SUBJECT: Ink Cartridge "O" Ring and Rubber Pad

FROM: Copier Technical Support Section

MODEL:

VT2100/2130/2150

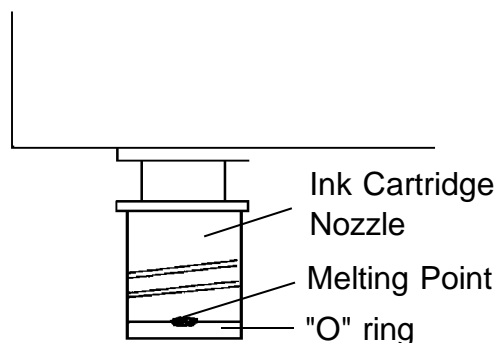
There has been a problem with the "O" ring inside the ink cartridge nozzle. The "O" ring comes off and remains on the nozzle of the ink pump when the ink cartridge is replaced, or it comes off and stays in the cartridge cap when the cap is removed. This occurs when the temperature changes radically making the "O" ring contract.

Note: To prevent the "O" ring from coming off, more than 2 points between the "O" ring and the ink cartridge nozzle were soldered as shown above. This melting process has been implemented since the March '91 production run. For a mark of the melting process, a black circle has been stamped on the end of the lot number. (Example: Lot No. 1911932 ◦)

Instruct customers on how to replace the ink cartridge. Have them follow this procedure:

1. Make sure that the "O" ring does not stay on the nozzle of the ink pump before a new ink cartridge is installed.
If it remains on the nozzle, remove it; otherwise the new ink cartridge cannot be set properly.
2. Make sure that the "O" ring does not stay in the cartridge cap when the cap is removed from the ink cartridge nozzle.
If the "O" ring stays in the cartridge cap, remove the "O" ring from the cartridge cap and install it inside the cartridge nozzle.

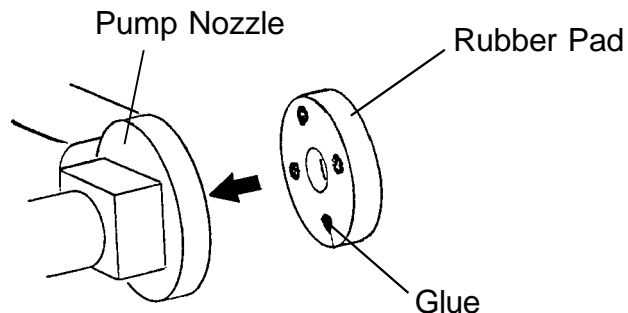
There has been a problem with the rubber pad located on the ink pump nozzle. It comes off when the ink cartridge is removed. When no rubber pad remains on the ink pump nozzle, ink inside the cartridge may not be pumped to the drum even if a new ink cartridge is installed. This problem does not happen very often.

Apply a strong adhesive (super glue) as follows:

1. Remove the rubber pad with a small screwdriver.
2. Clean the rubber pad and the ink pump nozzle (contacting place of the rubber pad) with cloth. If stains remain, clean them off with the thermal head cleaner.
3. Apply a little super glue to the 4 points on the rubber pad as shown.

Note: Do not apply too much glue. This is because the rubber pad cannot be inserted correctly if there is too much glue.

4. Insert the rubber pad into the pump nozzle.

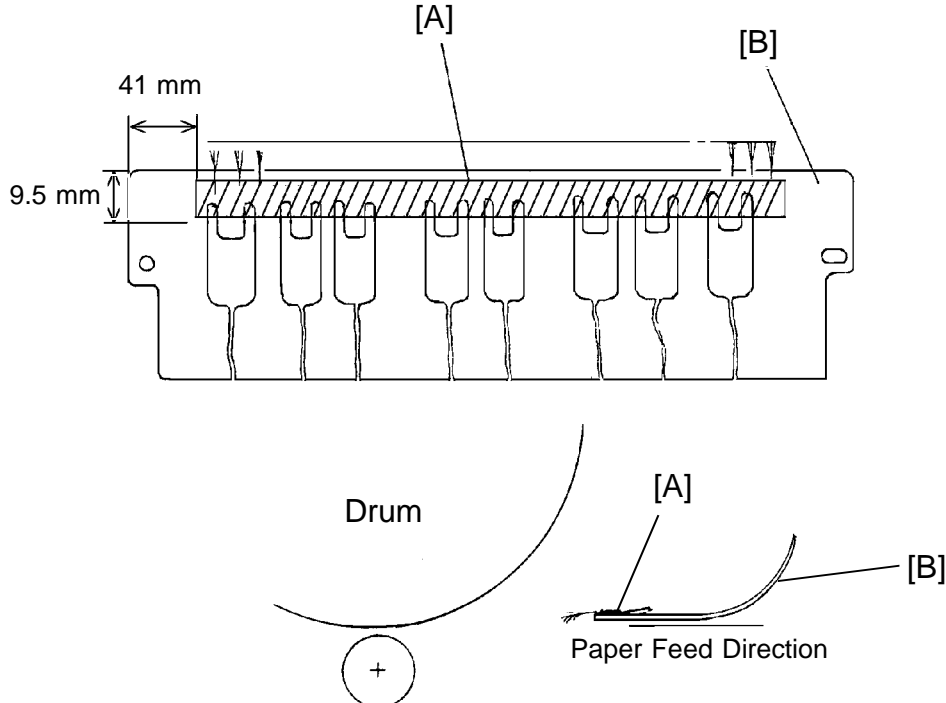
Paper jamming occurs around the drum because of static electricity when the machine is used under low humidity conditions. Heavy static charges will build up around the master during the printing run. This happens particularly when thin paper is being used at high speed rotations. This also happens if the original (and therefore the master on the drum) is changed.

Stick the antistatic brush (P/N: C2079010) [A] on the upper second feed roller guide plate [B] as illustrated below: (The antistatic brush has been registered as a spare part.)

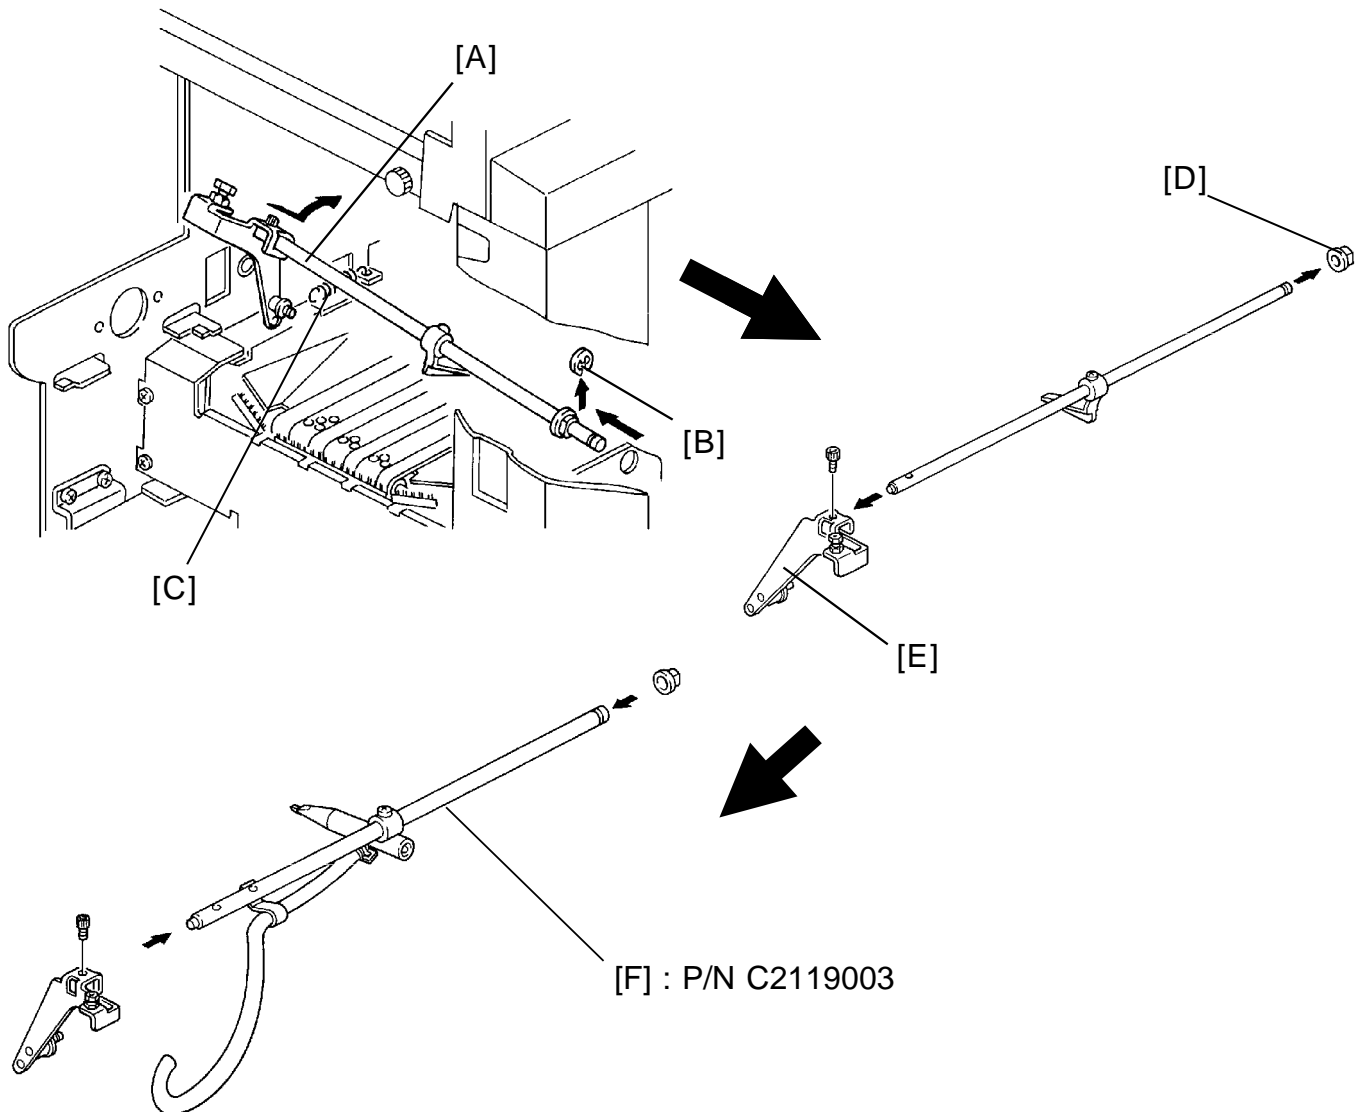
1. Open the master eject unit and remove the exit pawl assembly [A] (1 E-ring [B] and 1 spring [C]) from the machine .
2. Remove the bushing [D] and the exit pawl lever [E] (1 Allen screw) from the shaft.
3. Mount the above exit pawl lever on the new exit pawl shaft [F] (1 Allen screw used on the previous shaft) and insert the bushing onto the shaft.

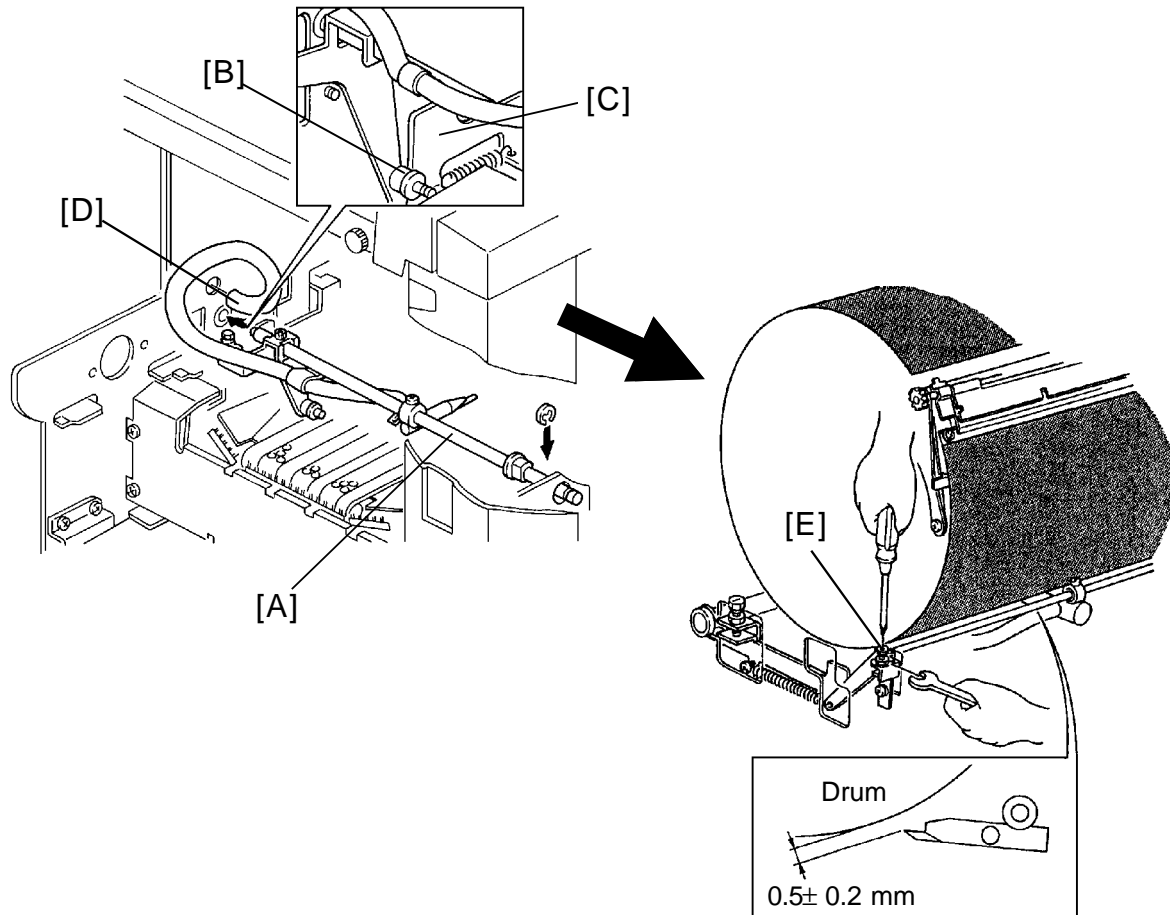
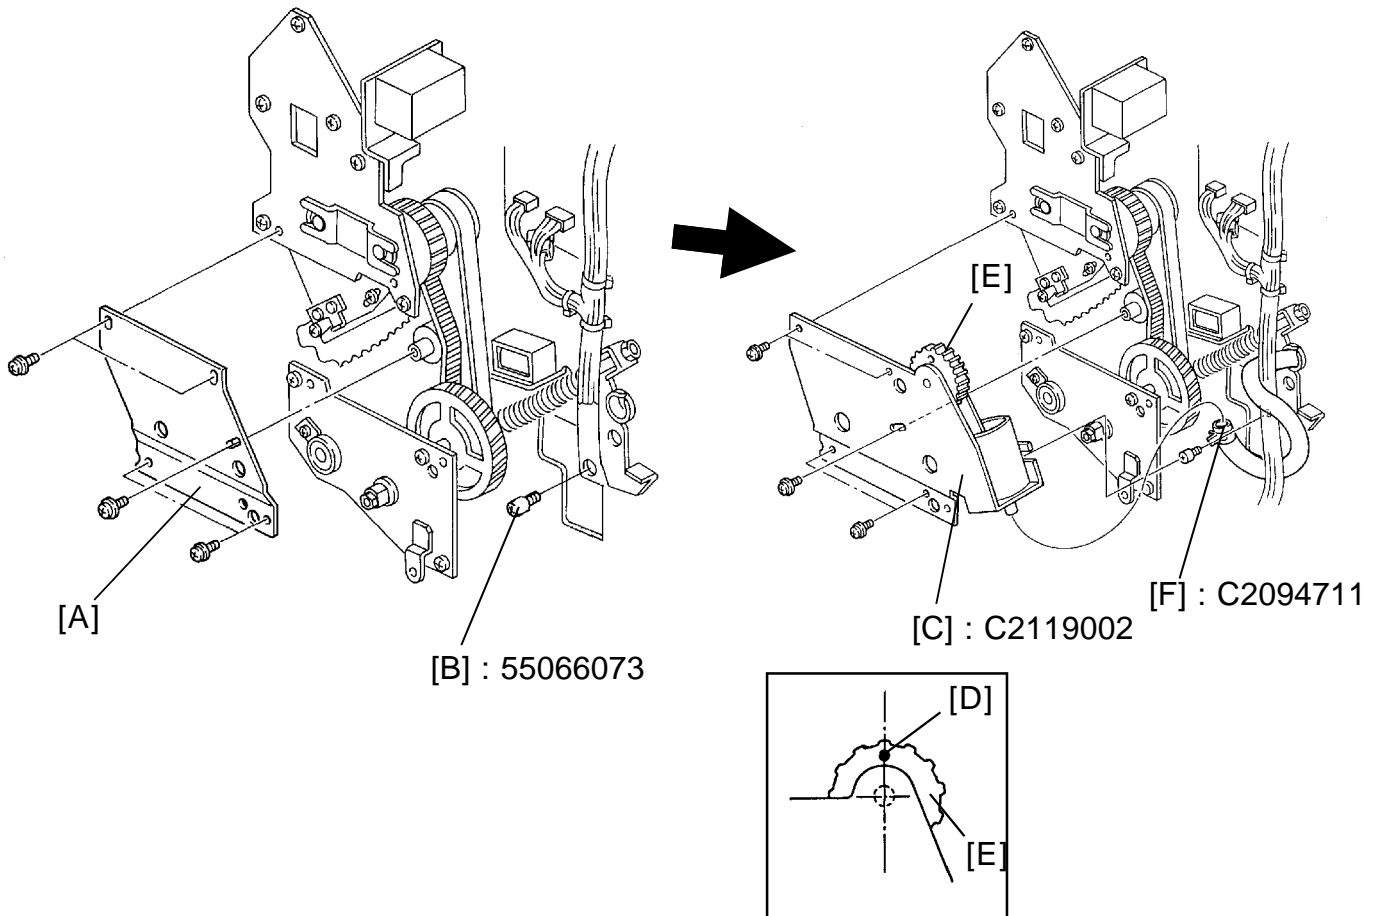
4. Install the new exit pawl unit [A](assembled on the previous page) to the machine (1 E-ring and 1 spring).

Note: Make sure that the collar [B] on the exit pawl lever is correctly placed on the exit pawl drive cam [C].

5. Insert the edge of the vinyl hose [D] into the hole on the rear side plate as shown.

7. When the printing pressure is applied, adjust the clearance between the drum and the exit pawl by turning the screw [E]so that it is 0.5 ± 0.2 mm.

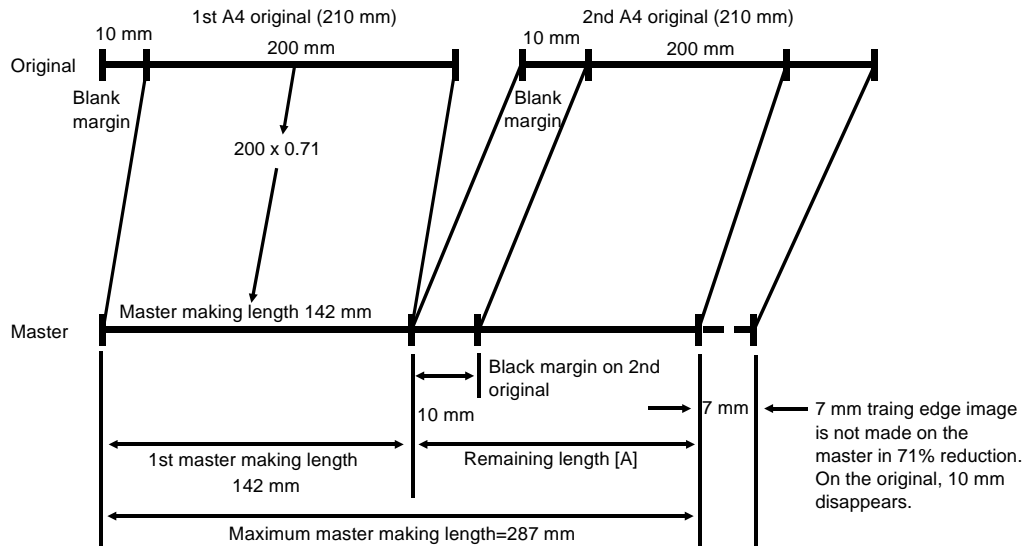
There have been reports in the field that the Combine 2 Originals mode is canceled when used with the 71% reduction mode and A4 sideways originals (210 mm width). This problem occurs on the VT2150 (A4 size machine).

On the VT2150 (A4 size machine), there is no room for variation in original length detection in Combine 2 Originals mode. Therefore, if the original feed speed is slightly slower than the standard speed and/or the original registration sensor actuator for detecting the original feed length does not move smoothly, this problem may occur in Combine 2 Originals mode.

1. When the 1st original is fed out, the remaining master making length [A] for the 2nd original is 145 mm. (**287 mm - 142 mm = 145 mm**)

2. In Combine 2 Originals mode, the ROM program detects whether the remaining length [A] (145 mm) is more than half of the maximum master making length (287 mm / 2 = 143.5 mm). If the remaining length is less than 143.5 mm, the Combine 2 Originals mode is automatically canceled before the 2nd original is fed in.

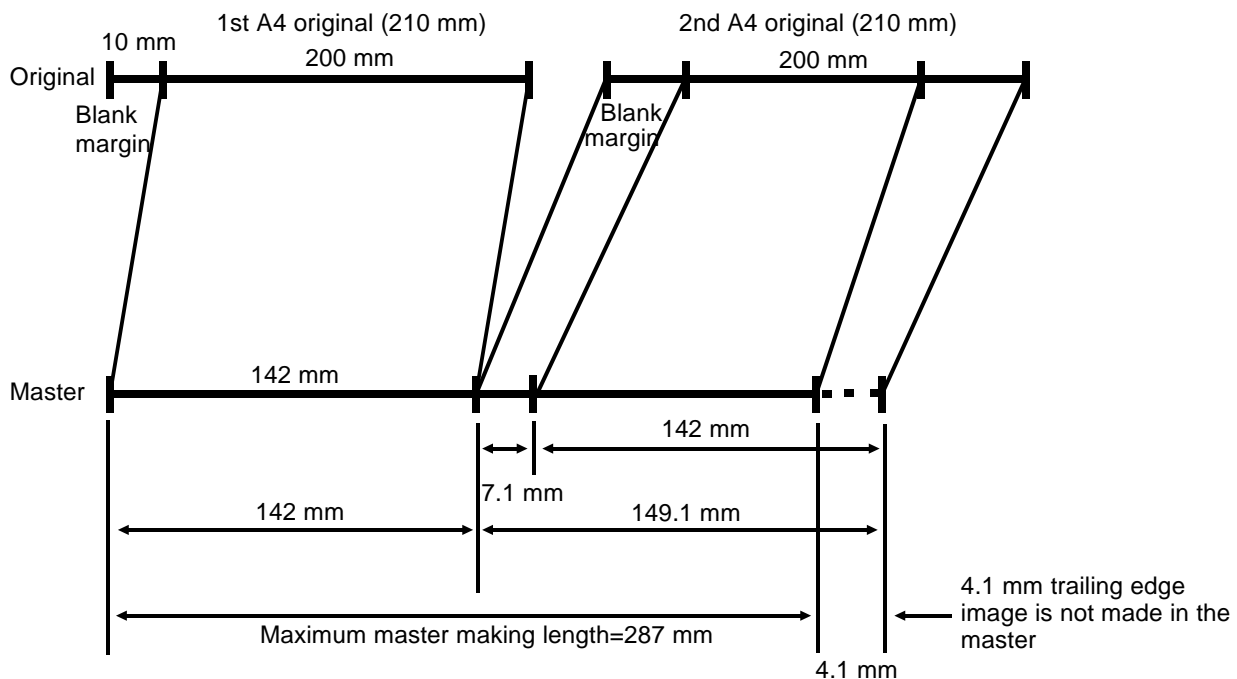
The ROM program relating to the original length detection in Combine 2 Originals mode has been modified as follows. This modification is applied to the B4/LG size machines (VT2100/2130) to standardize the function of Combine 2 Originals mode.

1. Apply reduction ratio for 10 mm leading edge image on the 2nd original.

2. Added a leeway of 5% of the length in original length detection in Combine 2 Originals mode.

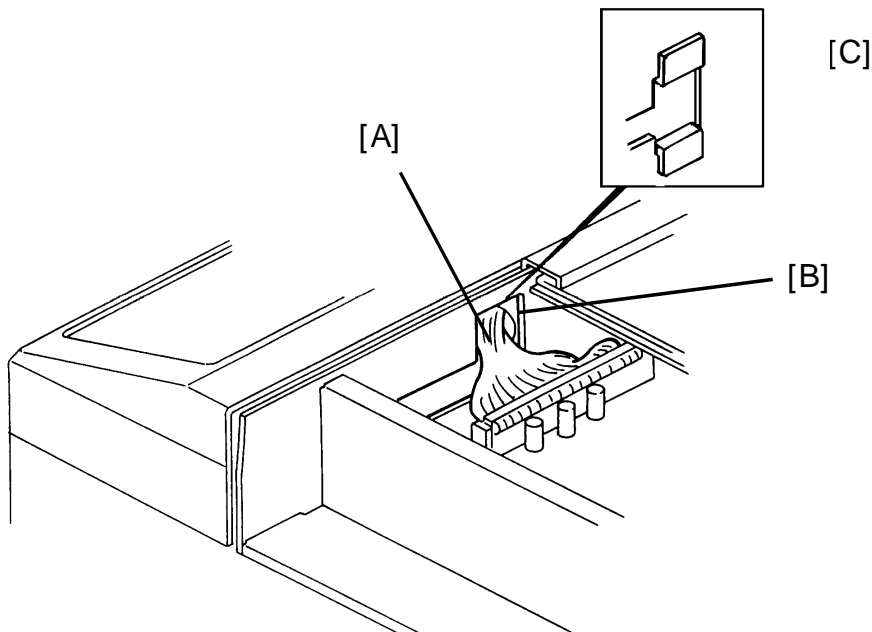
Flat Cable - A/D Conversion [A] (C2158012) is damaged by the edge of the scanner side plate cutout [B] and short circuited to the side plate.

1. File the edge of the sideplate cutout and cover it with insulating tape.
2. Bind the damaged area of the flat cable with insulating tape.

From December '92 production, the edge has been covered with rubber pads [C].

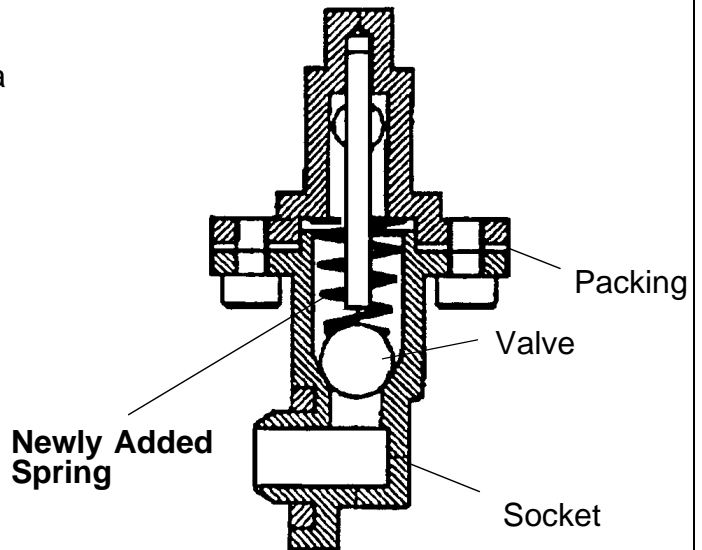
To ensure that all ink in the cartridge is supplied, a spring has been added inside the ink pump as shown to the right. The spring ensures that the small ball, which is used as a valve, is pushed back properly.

This modification has been applied from the September 1995 production runs of all Priport series models. The part numbers of the ink pump assemblies remain the same. (Note that the N850 and RN925 have been using the new type from the first mass production.)

SOLUTION IN THE FIELD

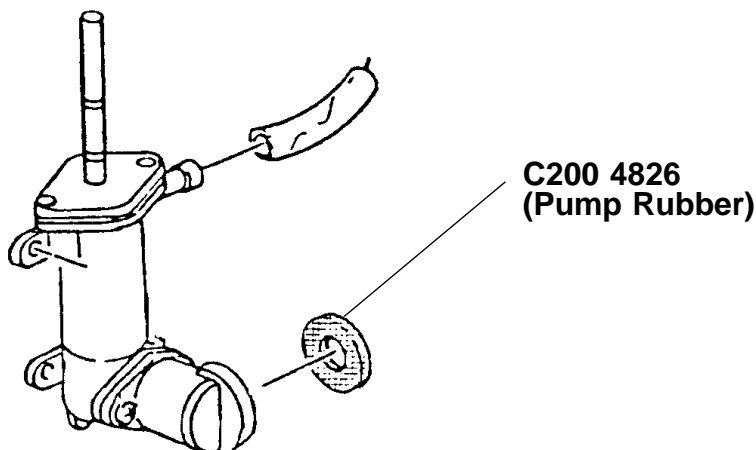
For the field machines, you can install the spring after removing the socket (with two screws). (It takes longer to replace the whole pump assembly.)

CAUTION: When you remove the socket, ink will leak. Be sure to place absorbant material to prevent the floor from becoming dirty with ink.

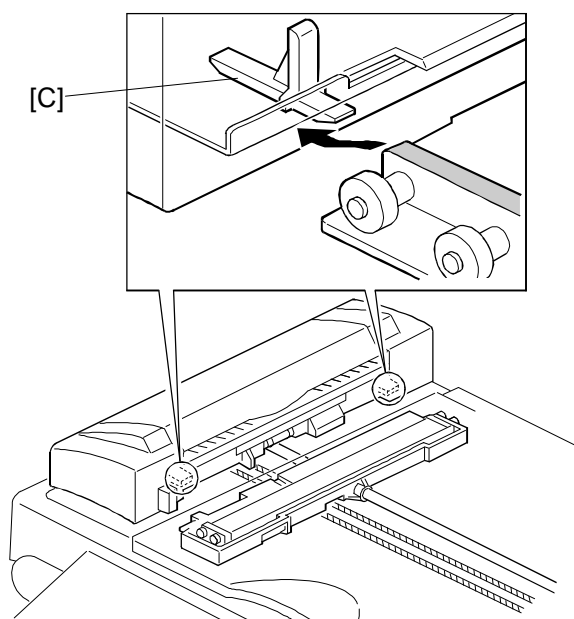
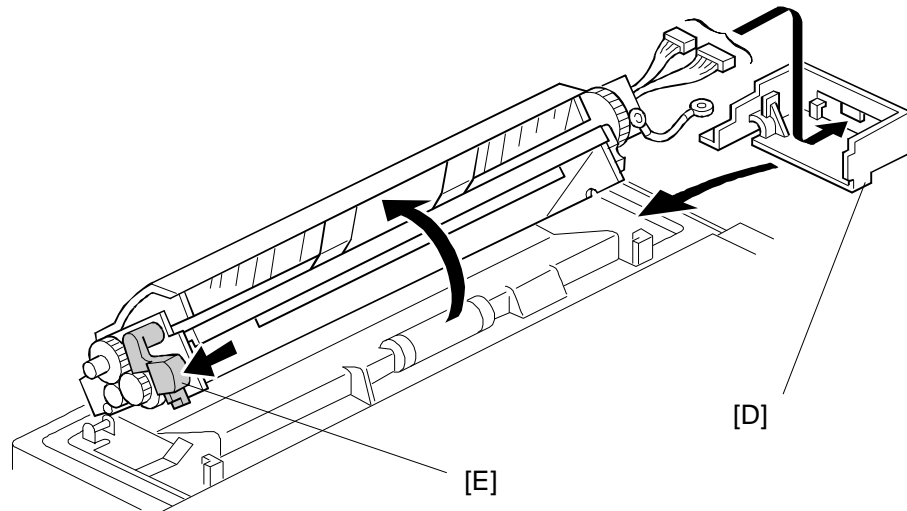
1. When you install the ADF unit [A] on the scanner unit, make sure to insert the tab [B] as shown above.

NOTE: If you do not follow the above instruction and the tab rides over the scanner unit frame, the ADF unit leans toward the right. There are guides [C], which are to guide both ends of the carriage, beneath the right end of the ADF (see the illustration above). Thus, these guides are just slightly lowered.

As a result, the carriage tends to be caught by the edge of the guides [C] while the carriage moves toward the original scanning position for the ADF mode. Even if the carriage is stopped on the way to the original scanning position, the master making process will happen as in the normal manner. However, as the original is not scanned properly, images will not be reproduced on the master, resulting in blank (or black) copies.

2. When you install the ADF Lower Rear Cover [D], at first you must open the ADF unit (flip it up) by pressing the Release Lever [E] as shown above.

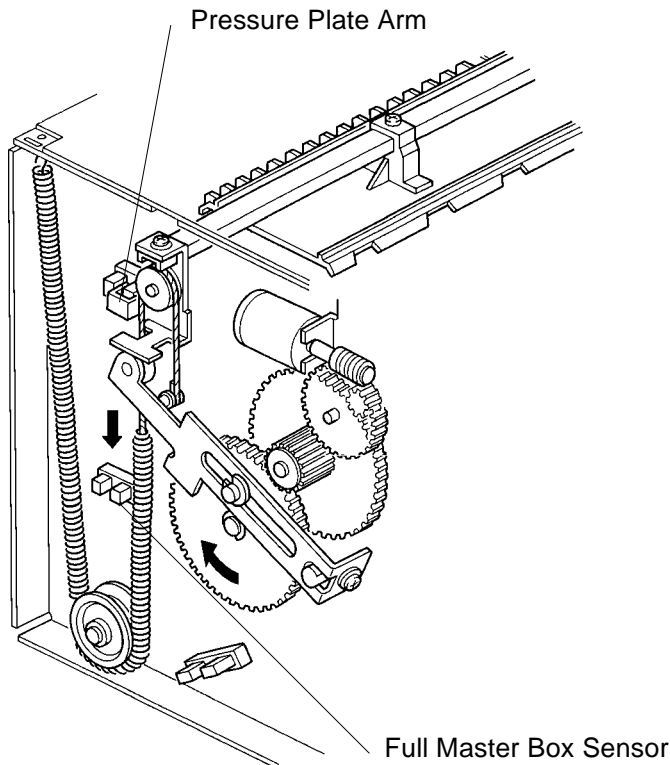
The new part has a narrower actuation plate as shown below. This means that the full master condition will be detected earlier than before.

If **SOLUTION 1** is not good enough, install the new part on the operation side of the master eject unit (see below).
